Rev	Date	Descriptor
LBC01	18.05.2024.	Listed Building Consent
projec	•+	
131_9 Wedderburn Road		
site address		
9 Wedderburn Road London		
NW3 5QS		
^{client} Private Client		
drawing title		
Lightwells		
project number_drawing number_revision 131_409_LBC01		
^{date} 18.05.2024.		
designed / drawn by 4H Architecture		
07515772458		
info@4harchitecture.co.uk		
scale

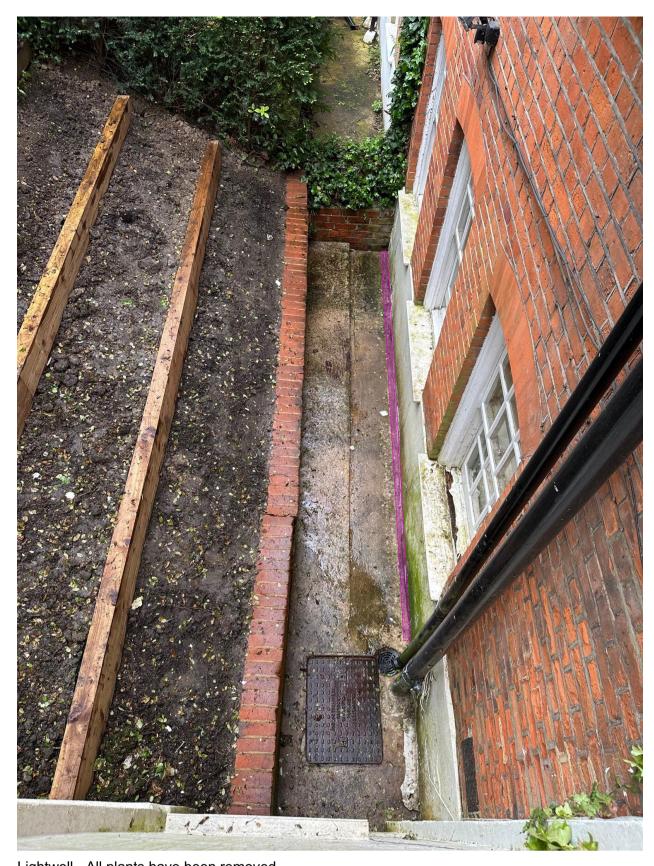
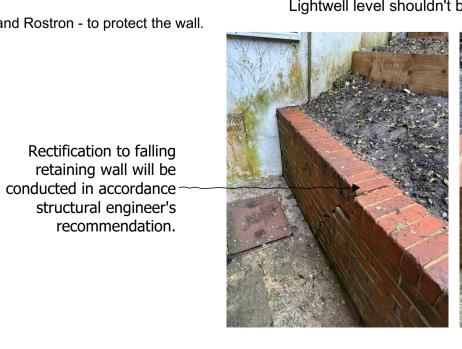
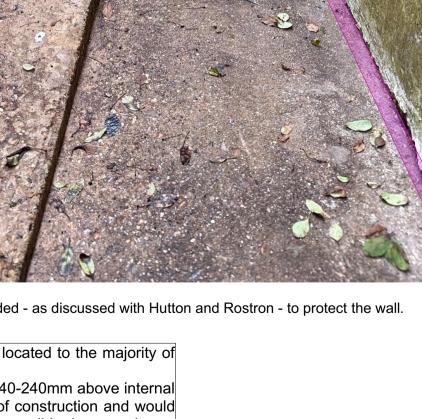
External walls: The external walls were not inspected in detail. The external walls were of Flemish bonded red brick solid masonry construction. There was a rendered plinth extending up to around window level (880mm). Some areas of localised spalled brickwork were observed to the east and west of the main entrance stairs. A mortar

The spalling brickwork is unlikely to cause penetrating dampness on its own, however it would effectively reduce the effectiveness of the wall, increasing the risk of penetrating dampness if any other defects were to occur. The rendered plinth could be removed (up to DPC level) at low level to increase evaporation from the wall and to stop dampness tracking up and potentially bridging the DPC

the elevation. In front of the lightwells there were sloped ground with retaining walls at the toe. To the east lightwell external ground levels were 140-240mm above internal floor levels which could lead to bridging of the DPC and dampness internally. The property likely benefits from a slate DPC given the age of construction and would have required one under local bylaws at the time, although this was not visible at the time of inspection. The lightwell to the west was not accessible, however it was expected to be similar. Lightwells in areas were filled with large plant pots which could be hindering their effectiveness in terms of both drainage and evaporation from the wall. One small section of earth retaining wall was observed to the west, almost to the west elevation. External ground levels were raised for a path leading into the 9A and B Wedderburn Road.

External ground levels should be lowered within the lightwells to at least 150mm below internal floor levels or DPC level whichever is lower. Lightwells should be cleared of any plant pots and sufficient drainage provided so that they do not retain water. Walls which are earth retaining would typically require some form of underground protection in line with BS8102:2022. No injected DPCs are required

Based on discussion with H&R the render plinth can stay as a cavity drain membrane will be installed and an ACO drain will be provided along the wall.

Lightwell - All plants have been removed ACO drain channel to be provided - as discussed with Hutton and Rostron - to protect the wall.

Based on our discussion with H&R the lightwell level will stay as it is dictated by the public manhole / drainage set out. ACO channels to be used, that will be a sufficient improvement.

Lightwell - All plants have been removed. Manhole cover to be replaced ACO drain channel to be provided - as discussed with Hutton and Rostron - to protect the wall.

Lightwell level shouldn't be changed as it affects the public manhole
